Access Compliance Report

Public Rights-of-Way

Intersection ID: 11610	Main Street: COLE_DR	Cross Street: GLENVILLE_AV	Location: NW
ADA ID: 8A0AD22C38D0	Ramp Type: ParaDiag	Initial Pass/Fail: Fail	Overall Compliance: No
		Severity Score: 12.5

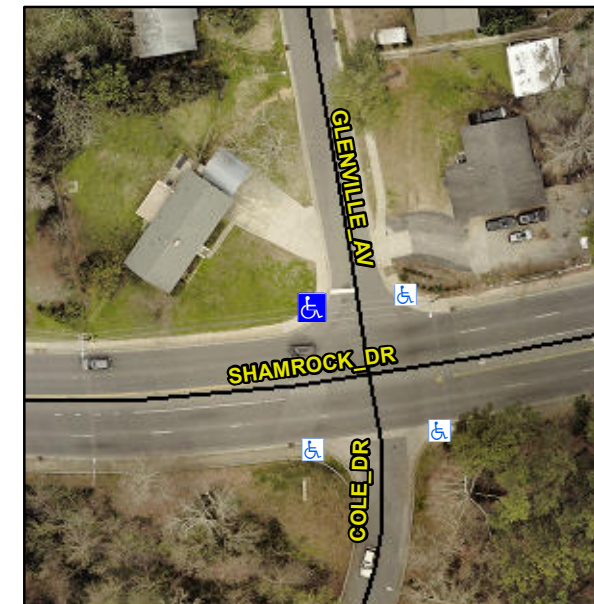
LT RP < 5%

R304.3.2

Compliance	Description	Data	Compliance	Description	Data
N/A	Ramp Length LT (in)	54.0	N/A	Ramp Length RT (in)	61.0
Yes	Ramp Width LT (in)	59.0	Yes	Ramp Width RT (in)	60.0
Yes	Ramp Slope LT (%)	1.5	No	Ramp Slope RT (%)	9.2
Yes	Ramp XSlope LT (%)	0.3	Yes	Ramp XSlope RT (%)	0.7
N/A	Landing Length (in)	N/A	N/A	DWS Provided?	N/A
N/A	Landing Width (in)	N/A	N/A	DWS Contrast?	N/A
N/A	Landing Slope (%)	N/A	N/A	DWS Length (in)	N/A
N/A	Landing X Slope (%)	N/A	N/A	DWS Full Width?	N/A
N/A	Landing Curb? (Y/N)	N/A	N/A	DWS Offset (in)	N/A
N/A	Shared Landing?	N/A			
N/A	Gutter Ponding?	N/A	N/A	Gutter Slope (%)	N/A
N/A	Gutter Lip Ht (in)	N/A	N/A	Gutter X Slope (%)	N/A
N/A	Painted X Walk1?	No	N/A	Painted X Walk2?	No
	X Walk 1 Direction	To S		X Walk 2 Direction	To E
N/A	X Walk 1 Width (in)	N/A	N/A	X Walk 2 Width (in)	N/A
	X Walk 1 Slope (%)	3.4		X Walk 2 Slope (%)	5.0
	X Walk 1 X Slope (%)	4.3		X Walk 2 X Slope (%)	1.6
N/A	Ramp inside XWalk1?	N/A	N/A	Ramp inside XWalk2?	N/A

Remove & Replace Curb Ramp With Two New Directional Ramps or Equivalent.
